Product Change Notification / CENO-190AOR645

CCB 6059 Initial Notice: Qualification of EN4900G as a new Bottom Die attach material for selected KSZ8001 and KSZ8721 device families available in 48L TQFP (7x7x1.4mm) package.

PCN #: CENO-190AOR645

CCB 6059
Pre and Post Change Summary
PCN #: CENO-190AOR645

Pre Change

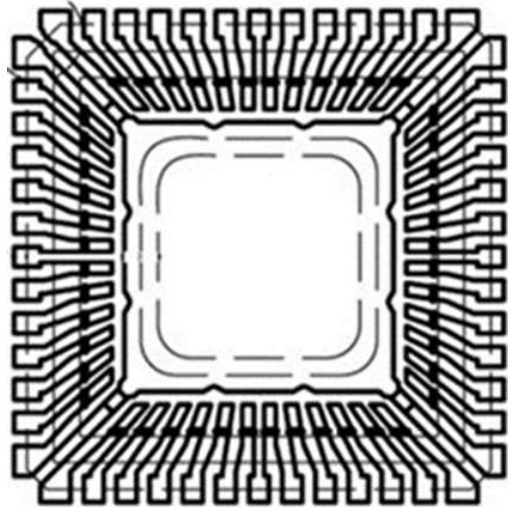
Lead Frame Material	C7025
Paddle size	160 x160 mils
Wire Material	Au

Post Change

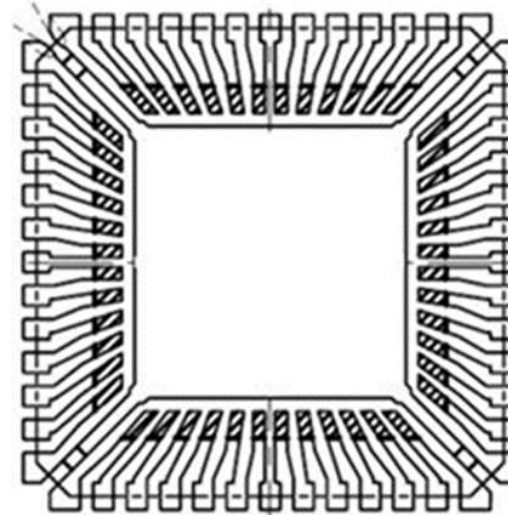
Lead Frame Material	C7025
Paddle size	160 x160 mils
Wire Material	Au
